Service Bulletin No: 32-006

Modification No: EC-10-0569

**LANDING GEAR - MAIN GEAR AND DOORS
REPLACEMENT OF THE WASHER ON THE MAIN LANDING GEAR (MLG) GAS STRUT ATTACHMENT-
BOLT****1. Planning Information****A. Effectivity**

Replacement of the Washer on the MLG Gas Strut Attachment-Bolt
Figure 1, Sheet 1 of 2

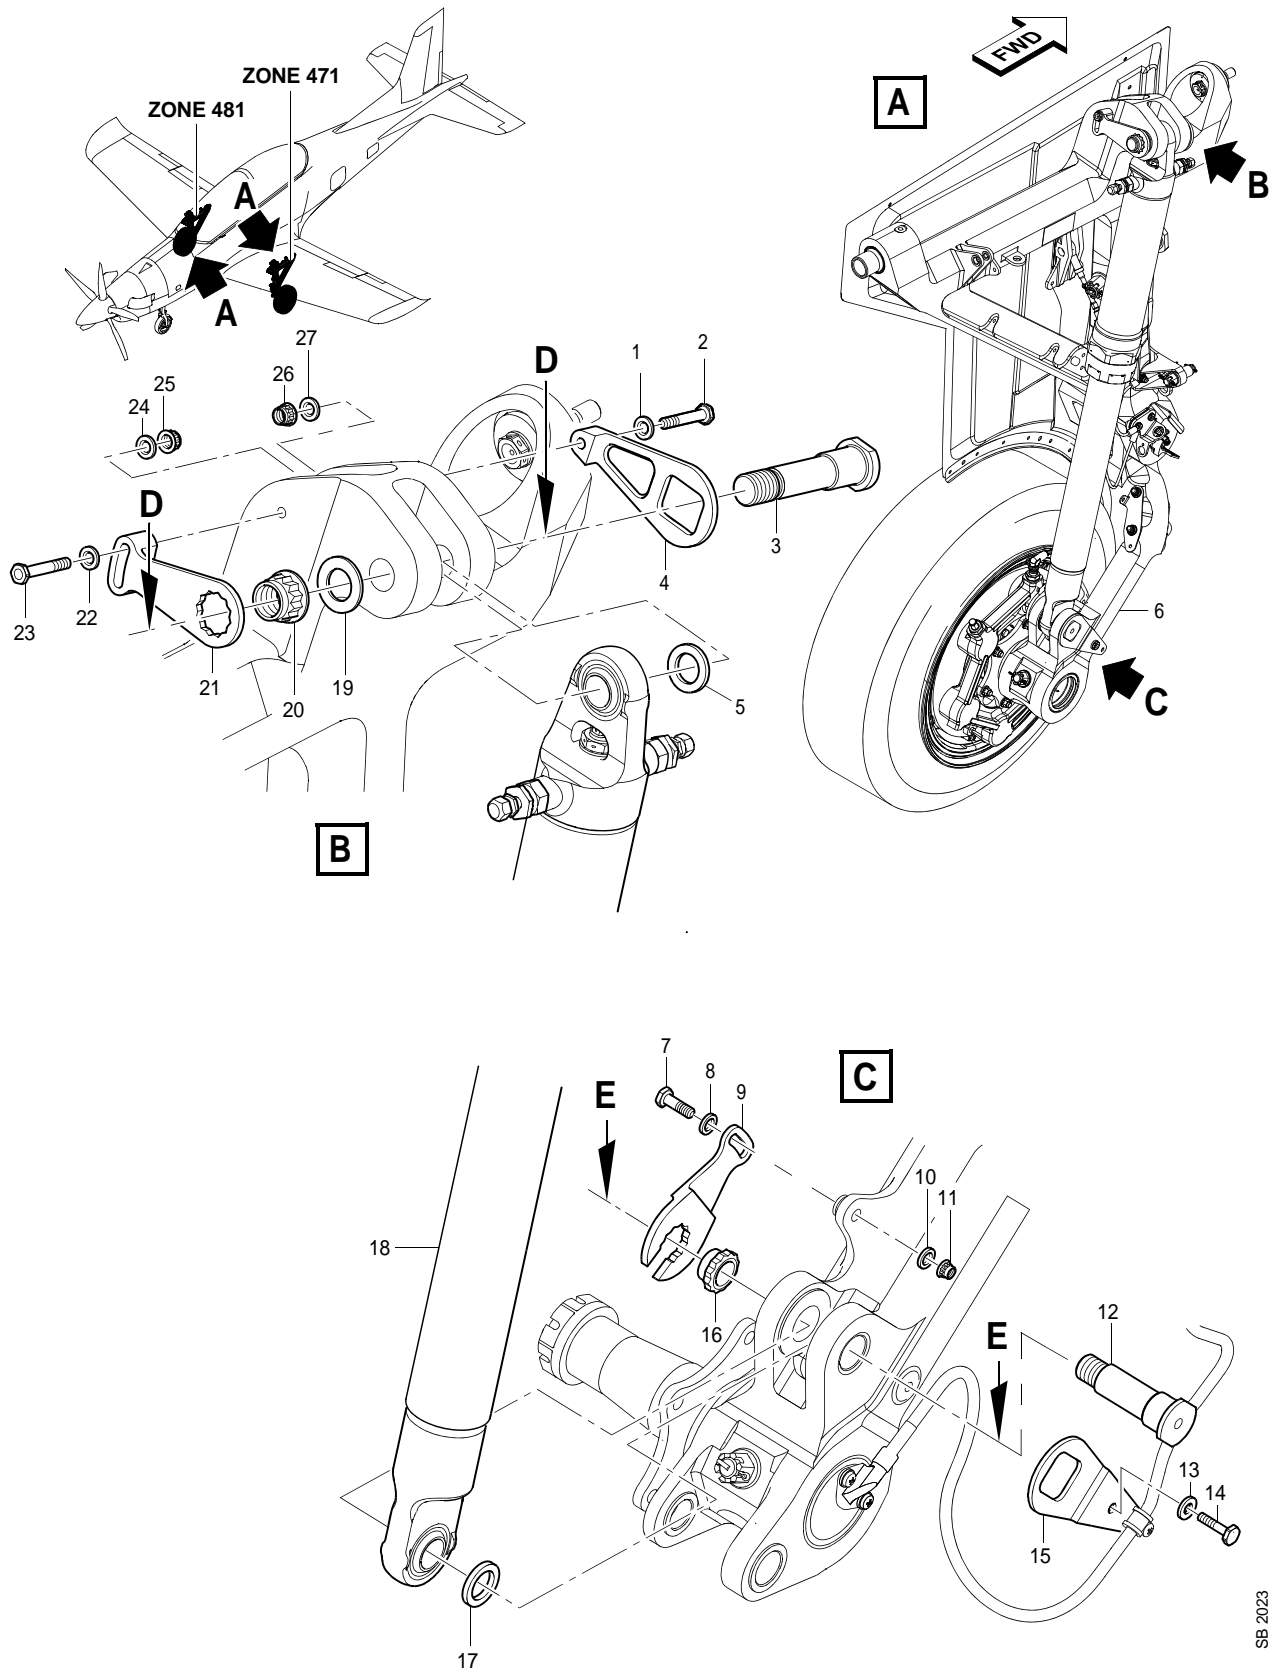
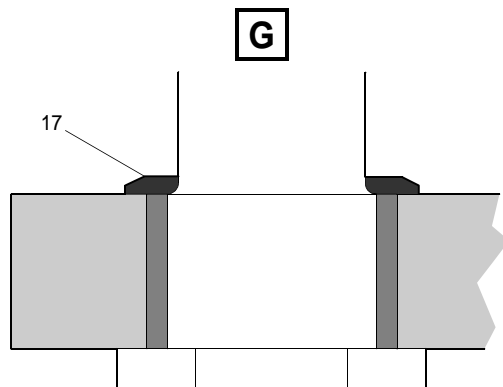
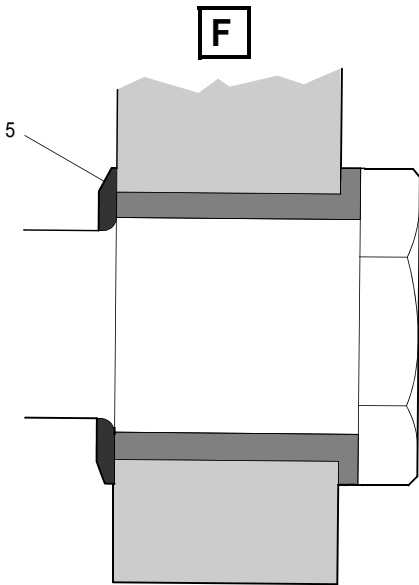
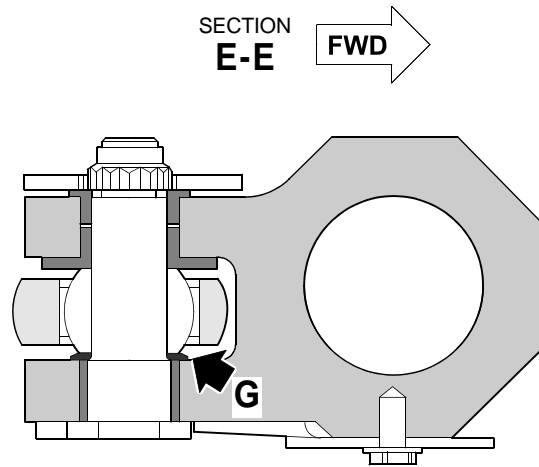
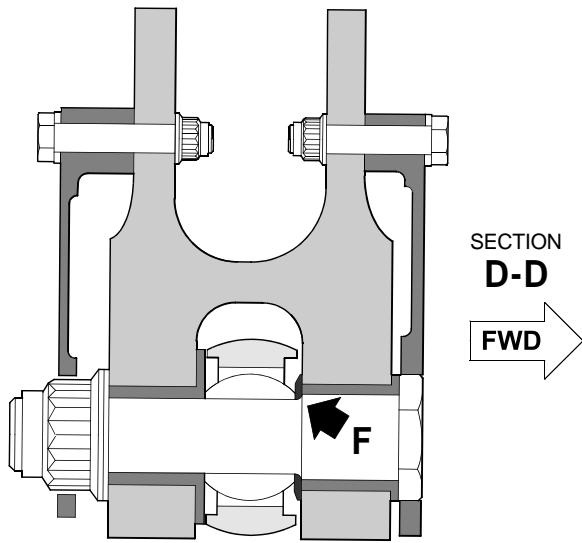
On some PC-21 aircraft, the special washer installed between the gas strut and its attachments on the MLG was found installed incorrectly. When installed incorrectly, the non-rounded edge of special washer is pushed into the shoulder of the attachment bolt.

This can cause fatigue/corrosion failure of the bolt.

Replace the special washer (P/N 532.10.21.095) with improved design special washer (P/N 532.10.21.203).

NOTE: The new special washer (5) (P/N 532.10.21.203) has a radius on the internal hole and a chamfer on the external diameter. The correct position for the new special washer (5) (P/N 532.10.21.203) is when the chamfer (on the external diameter) is away from the head of the bolt (3) (Ref. Detail F).

NOTE: The new special washer (17) (P/N 532.10.21.203) has a radius on the internal hole and a chamfer on the external diameter. The correct position for the new special washer (17) (P/N 532.10.21.203) is when the chamfer (on the external diameter) is away from the head of the bolt (12) (Ref. Detail G).
